Access Compliance Report

Public Rights-of-Way

Intersection ID: 50023	Main Street: SPRINGFIELD_GARDENS_DR	Cross Street: WYALONG_DR	Location: SE
ADA ID: 12F13999381A	Ramp Type: Perp	Initial Pass/Fail: Fail	Overall Compliance: No
Severity Score: 12.5			
Codes/Mitigation Info/Possible Solution		Field Measurements/Component Compliance

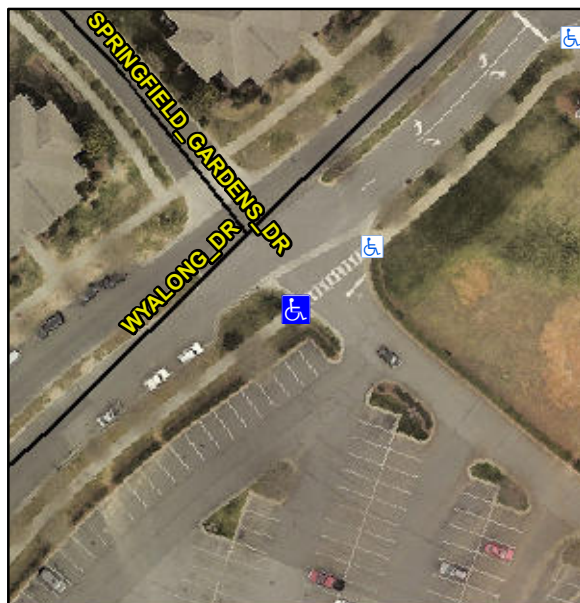
Not Found, R304.2.2

Compliance	Description	Data	Compliance	Description	Data
N/A	Ramp Length (in)	108.0	No	Ramp Slope (%)	8.4
Yes	Ramp Width (in)	71.0	Yes	Ramp XSlope (%)	1.4
N/A	Flare Type LT	N/A	N/A	Flare Type RT	N/A
N/A	Flare Slope LT (%)	N/A	N/A	Flare Slope RT (%)	N/A
N/A	Flare Traversable LT?	N/A	N/A	Flare Traversable RT?	N/A
N/A	Landing Length (in)	N/A	N/A	DWS Provided?	N/A
N/A	Landing Width (in)	N/A	N/A	DWS Contrast?	N/A
N/A	Landing Slope (%)	N/A	N/A	DWS Length (in)	N/A
N/A	Landing X Slope (%)	N/A	N/A	DWS Full Width?	N/A
N/A	Landing Curb? (Y/N)	N/A	N/A	DWS Offset (in)	N/A
N/A	Shared Landing?	N/A			
N/A	Gutter Ponding?	N/A	N/A	Gutter Slope (%)	N/A
N/A	Gutter Lip Ht (in)	N/A	N/A	Gutter X Slope (%)	N/A
N/A	Painted X Walk1?	Yes	N/A	Painted X Walk2?	N/A
	X Walk 1 Direction	To NE		X Walk 2 Direction	N/A
N/A	X Walk 1 Width (in)	70.0	N/A	X Walk 2 Width (in)	N/A
	X Walk 1 Slope (%)	3.2		X Walk 2 Slope (%)	N/A
	X Walk 1 X Slope (%)	3.4		X Walk 2 X Slope (%)	N/A

Remove & Replace Entire Ramp.
